## Appendix 'A'

977 West 22nd Avenue

## **EVALUATION: SUPPORT (8-0)**

**ELEVATIONS**

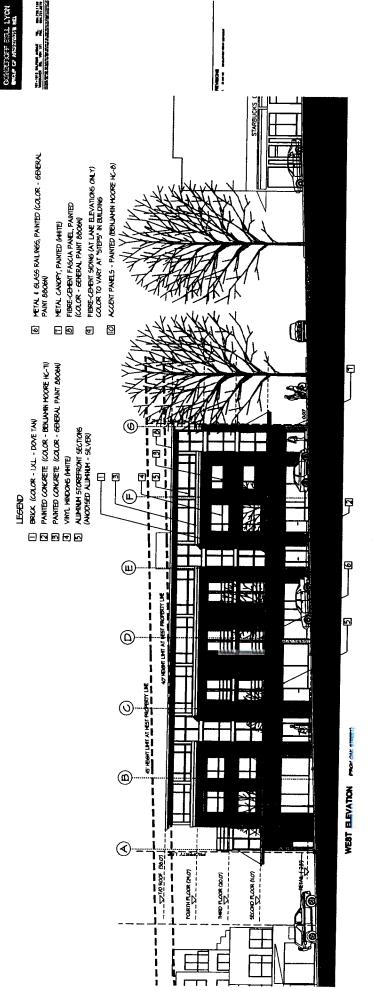
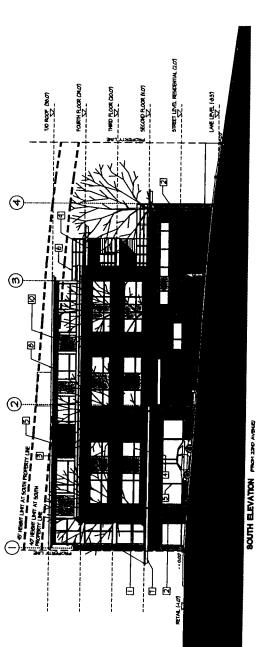
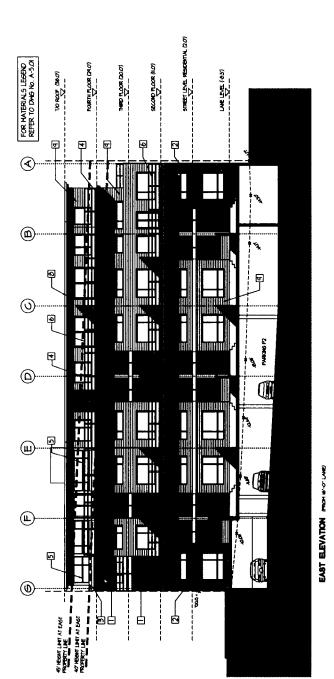
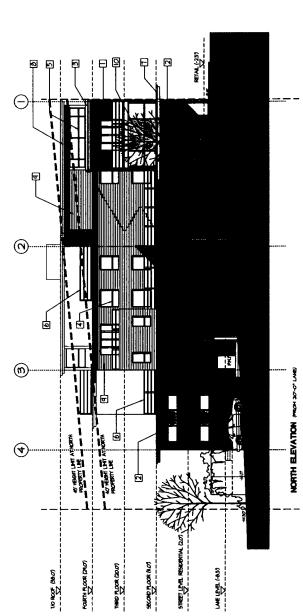
The Oak Street elevation was seen as the most successful. One comment was that the side elevations look like a different building, lacking the clarity of the Oak Street elevation.

The Panel stressed the need for improved detailing, particularly at ground level on Oak Street. Some Panel members questioned having the painted concrete at the base where it has the greatest visual impact, and the brick at the top. There were suggestions to bring the brick down to cover some of the

Attention should be given to proportions, particularly the size of the windows, e.g., at the corner of the Oak Street elevation the reduction in window size appears to be accidental.

## 45 FEET HIGH PROPOSED "STEPPED" BUILDING VIEW LOOKING NORTH-WEST (RED LINE INDICATES HEIGHT OF MOUNTAINS)

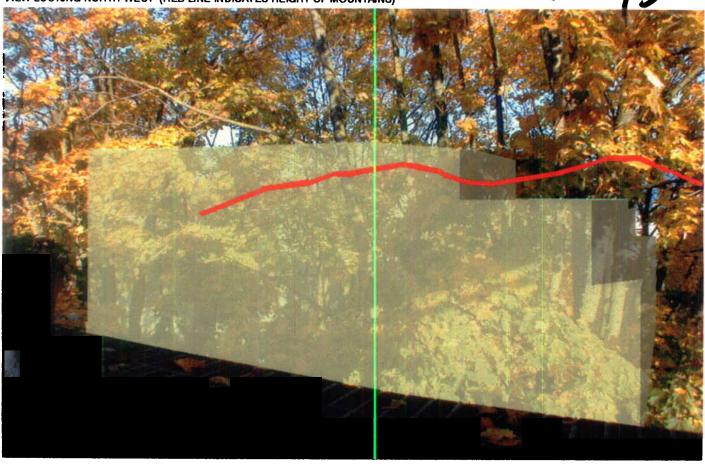
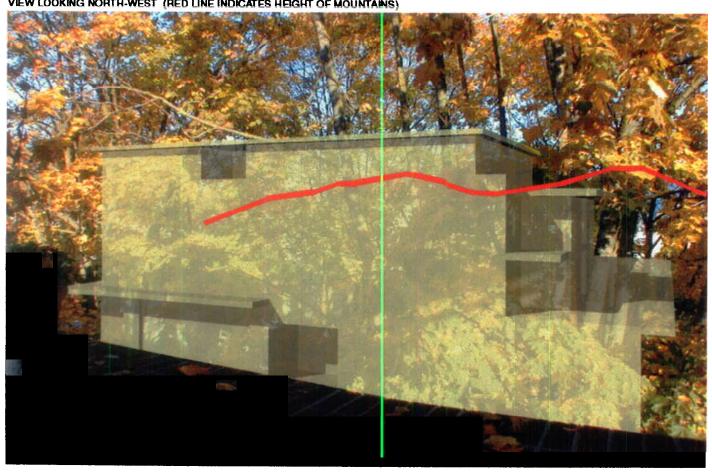
The height relaxation was strongly supported.
